Project: 3206 BASECAMP
1901 Curve Plaza
Steamboat Springs, Colorado 80487

RFI #42: Gas Main Location

System No. C-AJ-1140

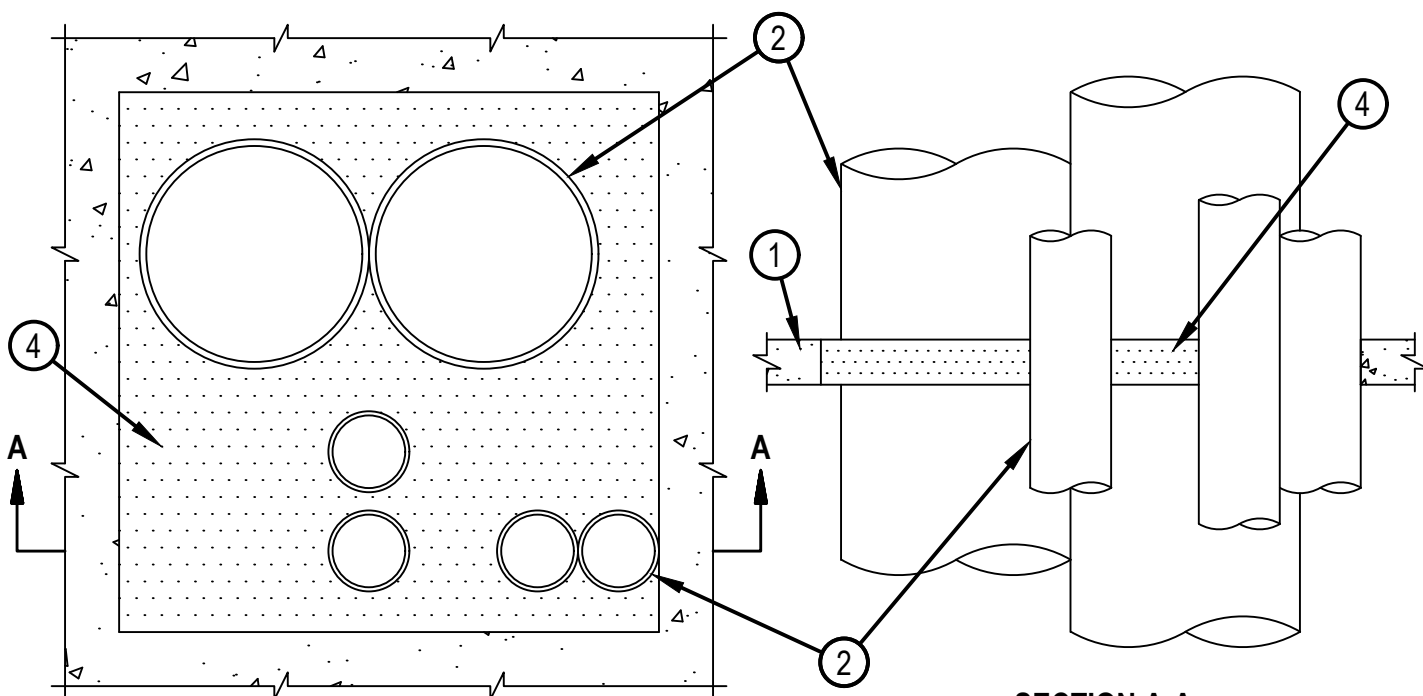
Question	<p>Question from Jason Bizzigotti DENEUE CONSTRUCTION SERVICES on Tuesday, Sep 13, 2022 at 07:03 AM MDT</p> <p>Please indicate gas main, size and how equipment will be regulated. Please make sure to note how fire-resistive structures are protected (if applicable) ex. Penetrating a 3 hour wall.</p> <p>Attachments Gas Main detail P4.11.pdf, Gas Main RFI.pdf</p>
Official Response	<p>Response from Kevin Sperry KASA on Thursday, Sep 29, 2022 at 08:55 PM MDT</p> <p>Please see gas meter location diagram with dimension to regulator, as well as (3) Hilti details which illustrate penetrations of metal conduits through 3-hour CMU walls.</p> <p>Attachments Approval-document-ASSET-DOC-LOC-77 (1).pdf, Approval-document-ASSET-DOC-LOC-75.pdf, 22-0929 - RFI42 - Gas Main Location.pdf, Approval-document-ASSET-DOC-LOC-85.pdf</p>
Official Response	<p>Response from Taylor Burchard Boulder Engineering on Wednesday, Sep 21, 2022 at 02:35 PM MDT</p> <p>Utility Company is providing 7"w.c. delivery pressure. Gas piping is shown from meters on sheet P2.12 and routes up exterior wall and then routes through ceiling cavity of the water room. House meter has a 4" manifold that has (2) 2" pipes to feed the boilers and (1) 2" pipe to feed the residential lobby rooftop unit, residential corridor makeup air units and the clubroom fire pit. Gas piping from gym meter and restaurant meter are being redesigned and are not known at this time.</p>
